Title: **Stage 1&2 ROAD SAFETY AUDIT**
For;
Dunlo Hill Development, Ballinasloe, Co. Galway.

Client: **Galway Co. Co.**

Report reference: **1846R01**

Drawing 2257/CE/002/PL, Dunlo Street Junction.

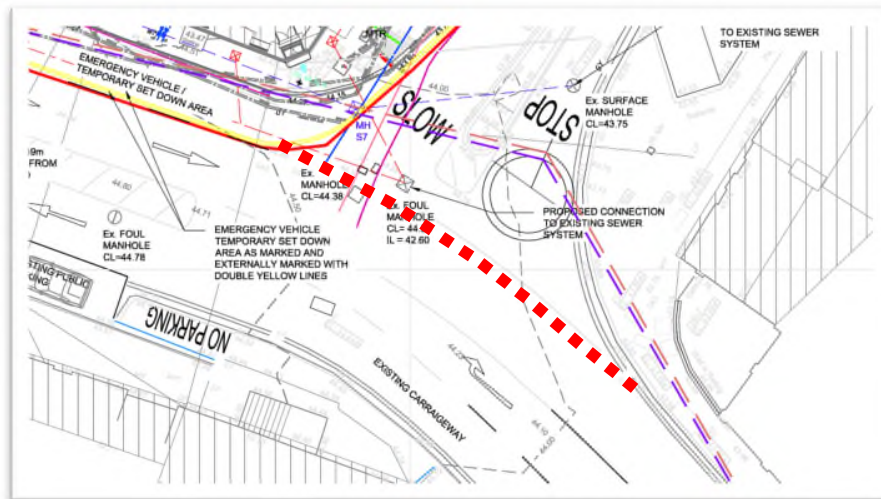
The stop line is set very far behind the edge of the R446 through route. This makes the visibility to the left for drivers exiting Dunlo Street appear worse than it actually is. The stop line may be ignored by drivers who are familiar with the area leading to a less formal yield control junction.

It is recommended that the stop line be brought forward to close top the edge of the through carriageway/new double yellow line.

Drawing 2257/CE/002/PL, Dunlo Hill.

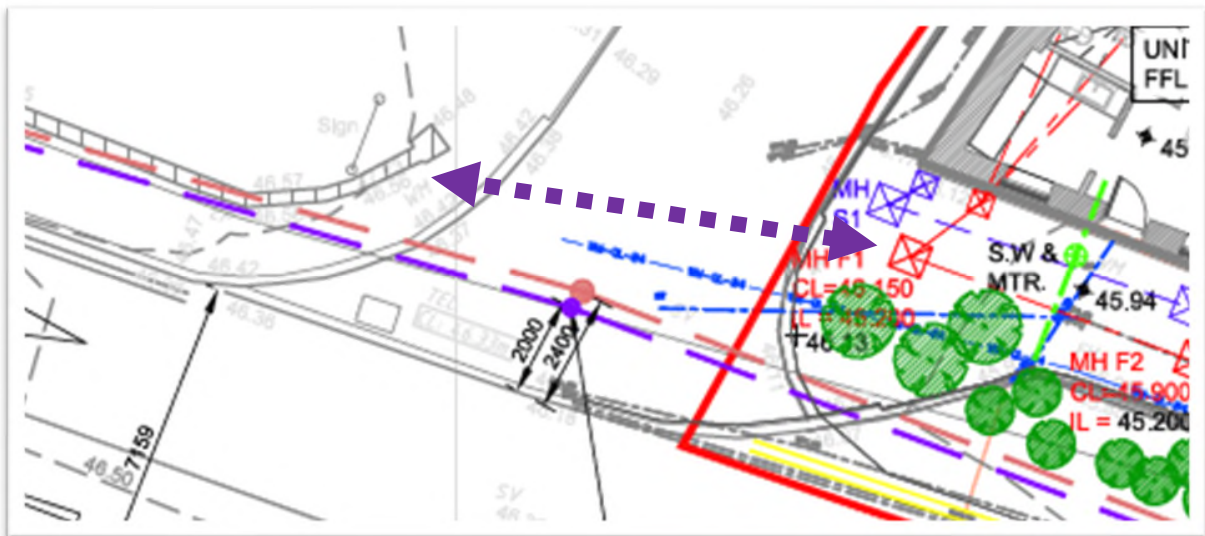
Pedestrians crossing the Dunlo Hill access road to the west of the site may not have suitable crossing facilities which could lead to trips and falls.

Ensure that suitable dropped kerbs and tactile paving is provided.

Problem Location Plan.

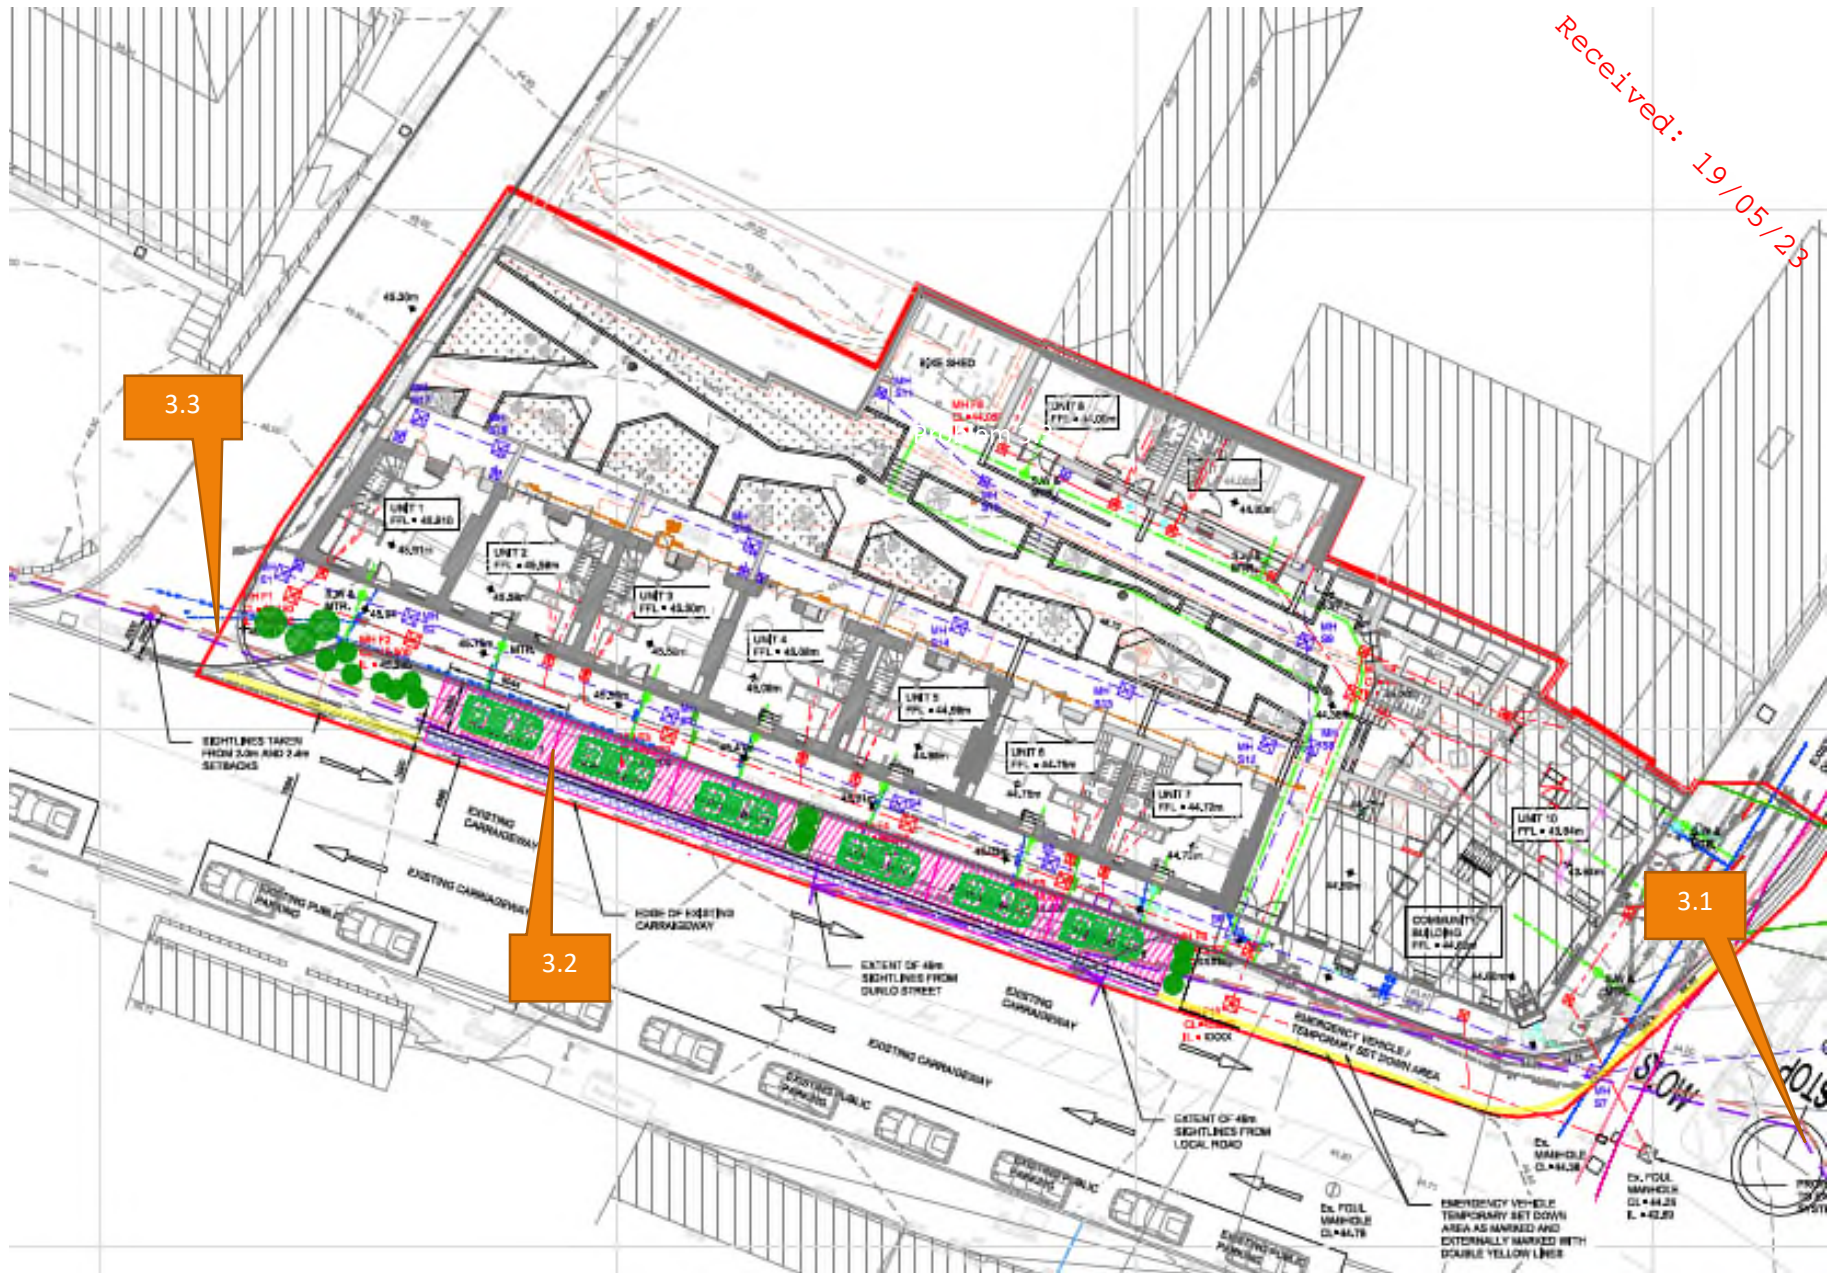
It is unclear where the bus stop on the R446 will be relocated to. Without a suitable stopping place the mobility impaired may not be able to access the bus.

Ensure that alternative arrangements are provided for bus users.
